# Access Compliance Report

## Public Rights-of-Way

### (Curb Ramps)

Intersection ID: 26681	Main Street: COUNTRY_LN	Cross Street: LOMA_LINDA_LN	Location:	E
ADA ID: 0B4D7BAE4BA5	Ramp Type: MedianPerp	Initial Pass/Fail: Pass	Overall Compliance: No	Severity Score: 2.5

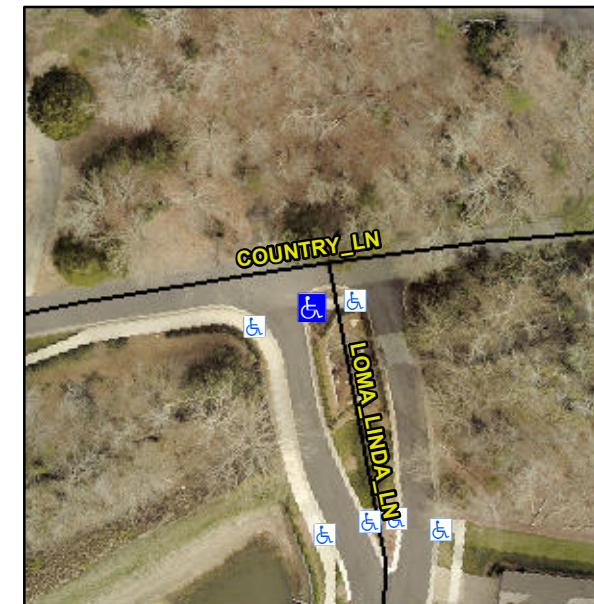
**Not Found, R304.2.1, R305.1.4, R305.2, R302.7**

**Remove & Replace Entire Ramp.**
